Product / Process Change Notification (PCN)

PCN Number: PCN_WPME-FISM_1779205341_20250120

Affected Series: WPME-FISM

Affected Part Number: 1779205341

CIRCUIT DESCRIPTION

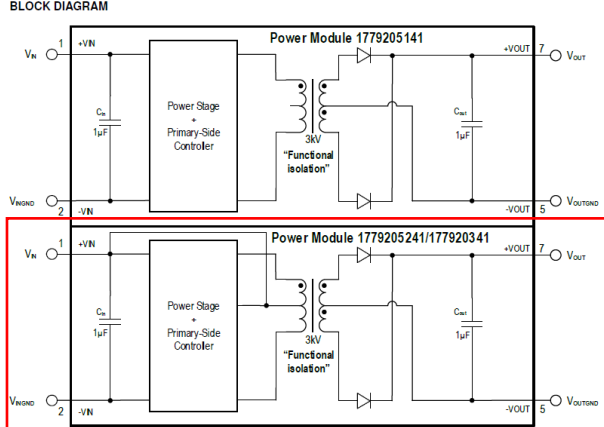
The modules still are based on either a full bridge or a push-pull topology. In some cases the single part number topology switched from previous full bridge topology to a push-pull topology or vice versa. The topology change is indicated in the BLOCK DIAGRAM chapter.

The Mag¹C power module 1779205141 is based on full bridge topology whereas the Mag¹C power modules 1779205341 / 1779205341 are based on a push-pull converter. All modules have an integrated IC, rectifying diodes, input and output capacitors and a transformer.

17 CIRCUIT DESCRIPTION

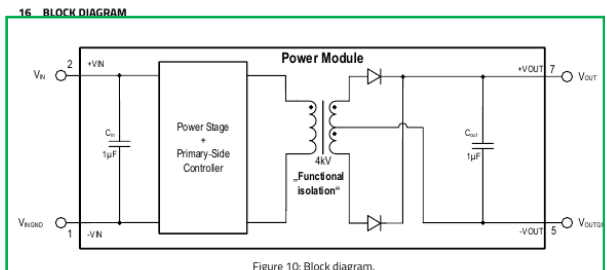
The Mag¹C power module 1779205341 is based on a full bridge topology. The module has an integrated IC, rectifying diodes, input and output capacitors and a transformer.

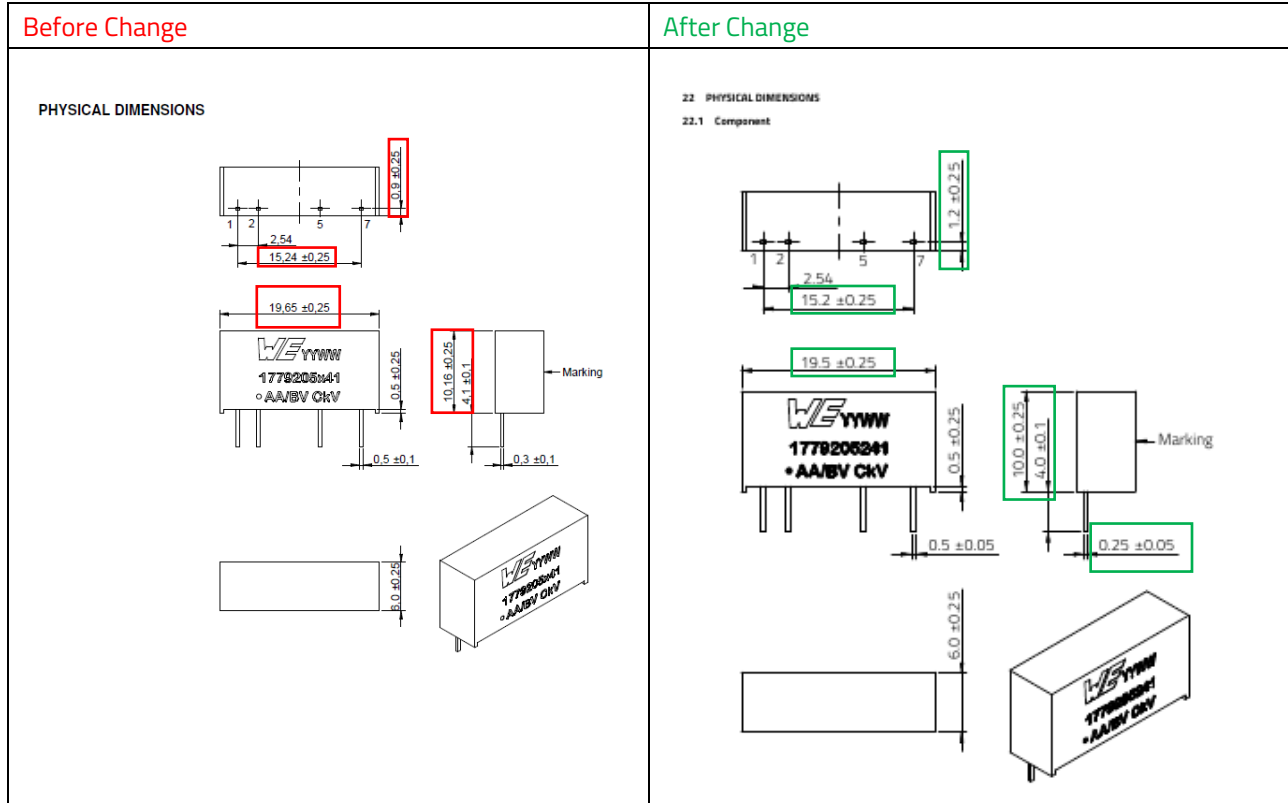
The mechanical dimensions have been updated based on new production. SIP-7 package shapes stay the same but with slightly deviated package length and height.

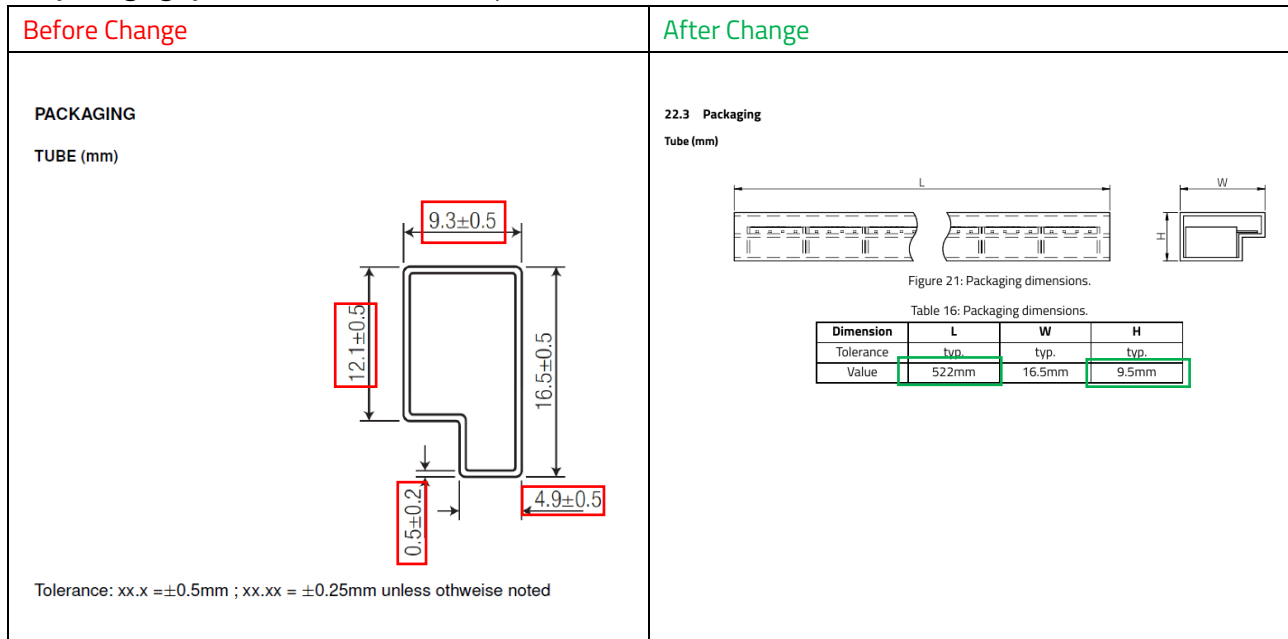
The packaging specifications have been adjusted.
